Historic Architectural Review Commission

Staff Report Item 2

Meeting Date:	October 28, 2014
Applicant:	Stefano de Luca, Architect
Application Number:	H14-01-1351
Address:	#500 Duval Street
Description of Work:	Renovation of storefront windows. New egress door and fire safety equipment at Old Kress Building.
Building Facts:	<p>The historic building is listed as a contributing resource. The two story masonry vernacular structure was built in 1918. The building is located on the south west corner of Duval and Fleming Streets. The structure will be converted into a CVS Store. The historic Kress signs will not be altered or removed.</p> <p>In October 23, 2012 the Commission approved plans for revisions to the first floor façade in order to match original openings. The design was never executed.</p>
Guidelines Cited in Review:	Commercial Storefronts and Signage (page 46), specific guidelines 1, 2 and 5.

Re: **HARC Certificate of Appropriateness**
CVS #10169
500 Duval Street
Key West, FL 33040

EXIST. CONDITION

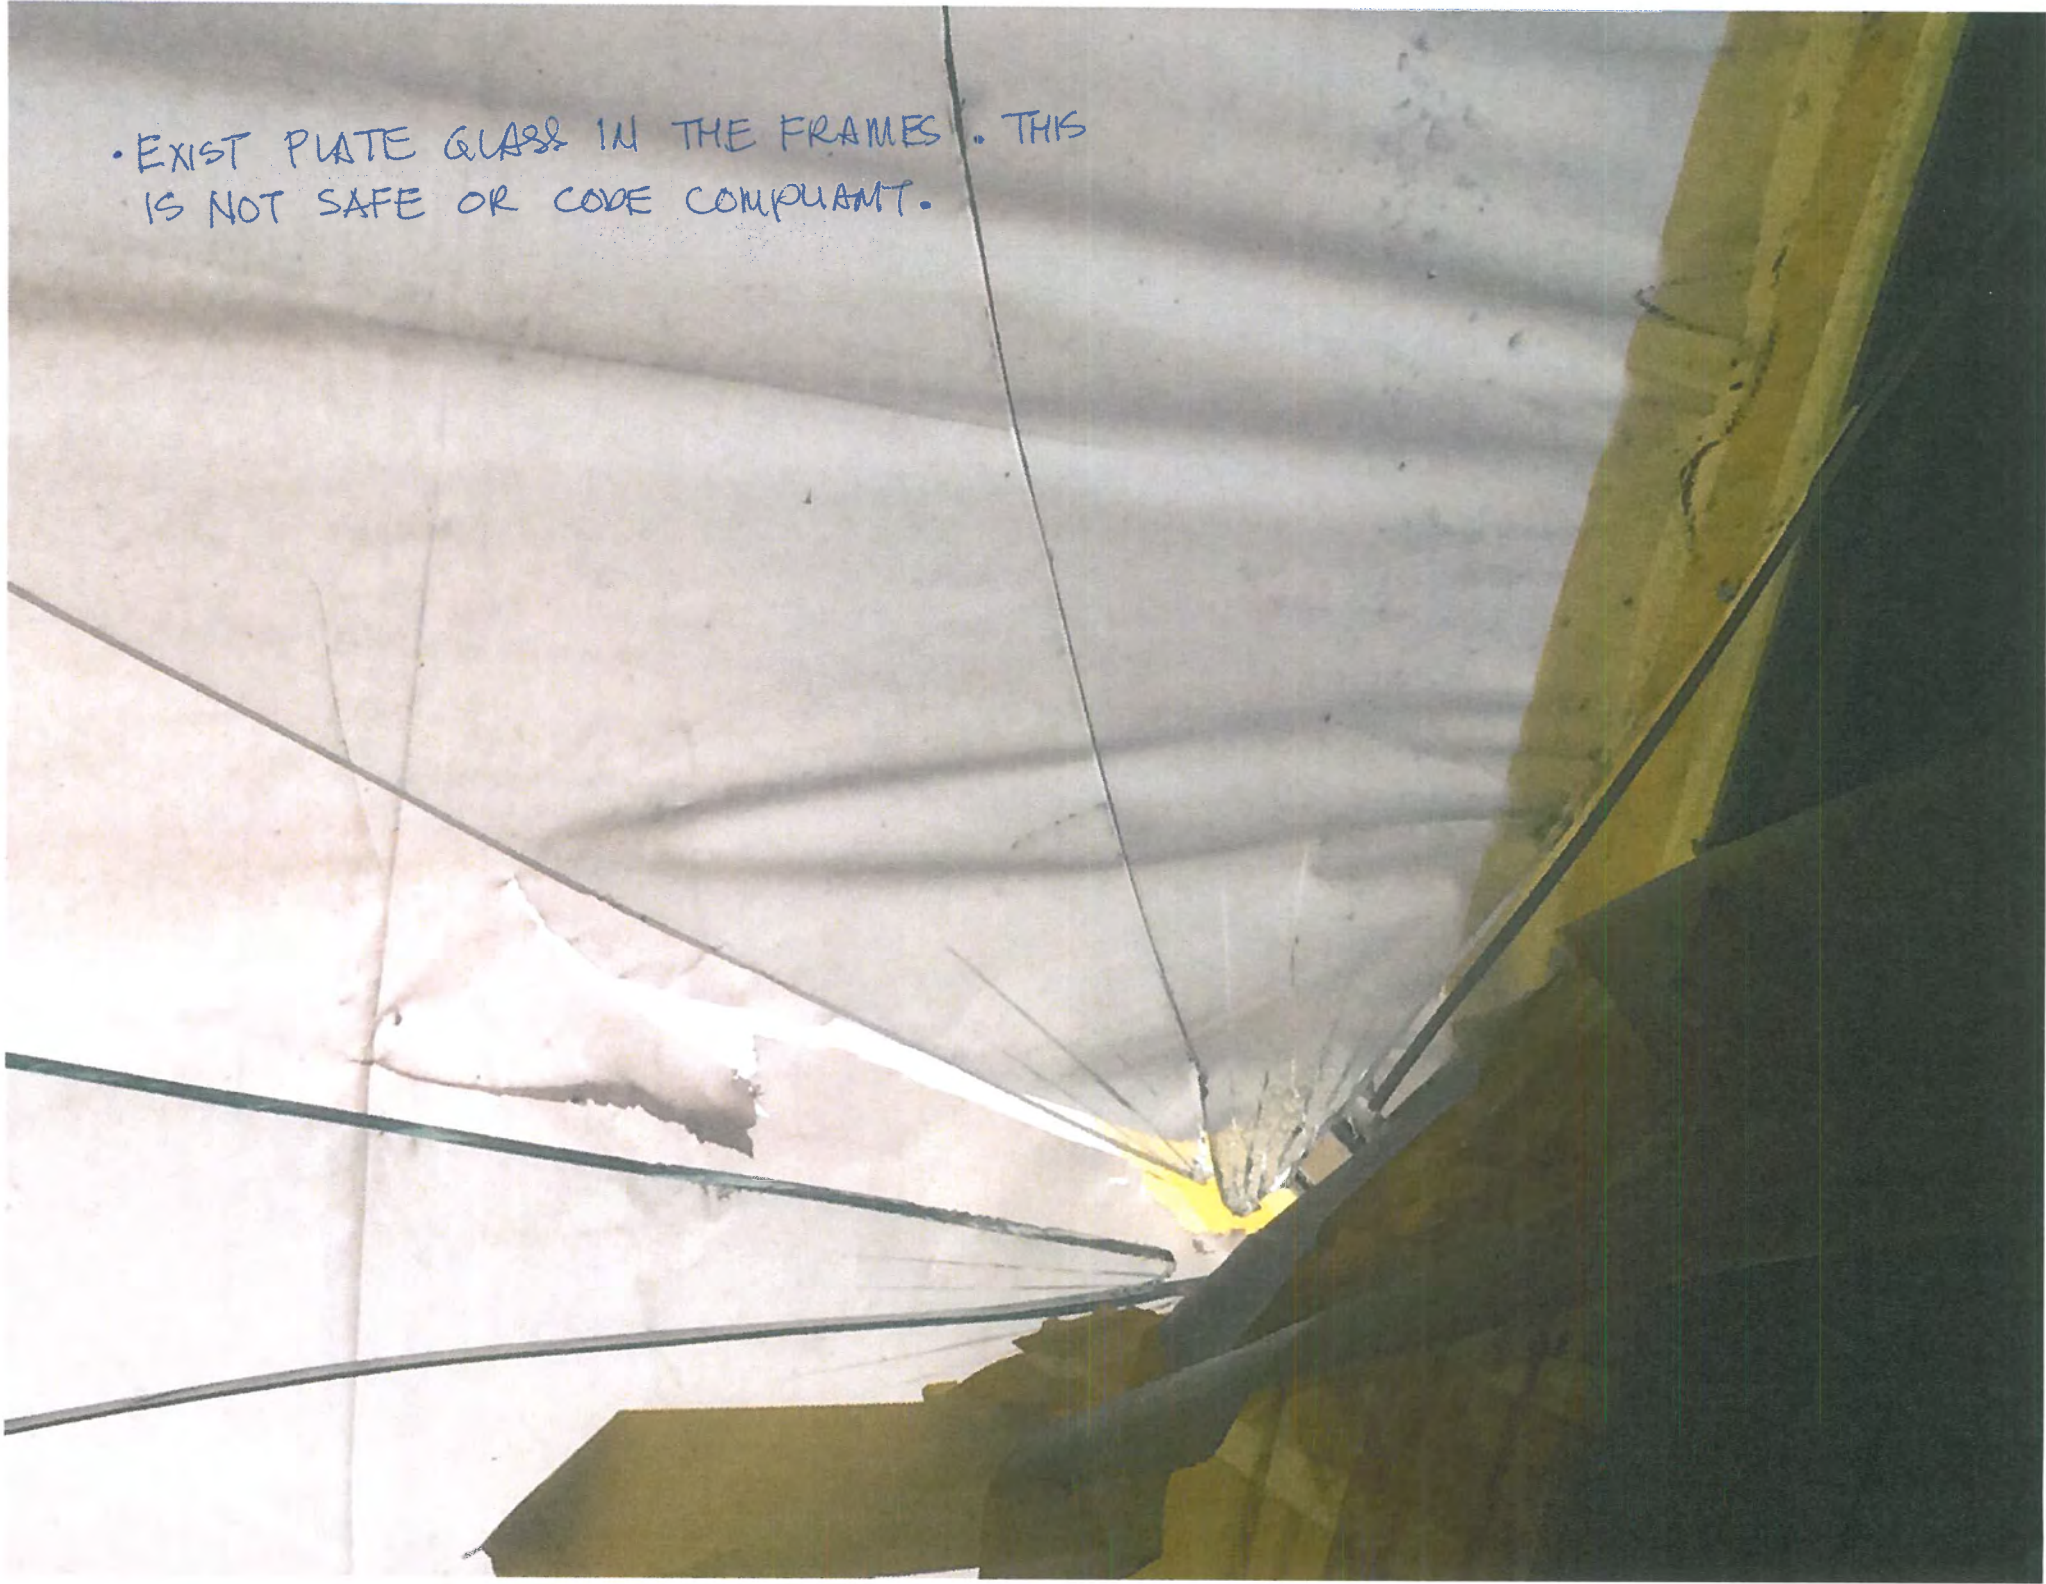
EXIST. WINDOW FRAMES ARE IN POOR CONDITION & APPEAR TO HAVE BEEN CONSTANTLY REPAIRED W/ BANDAGE REPAIRS.

• EXIST PLATE GLASS IN THE FRAMES. THIS IS NOT SAFE OR CODE COMPLIANT.

EXIST. WINDOW FRAME. WOOD BLOCKING WAS IN BAD CONDITION & ALLOWED THE WINDOW FRAME TO MOVE. THIS IS TYPICAL FOR ALL EXIST. FRAMES.
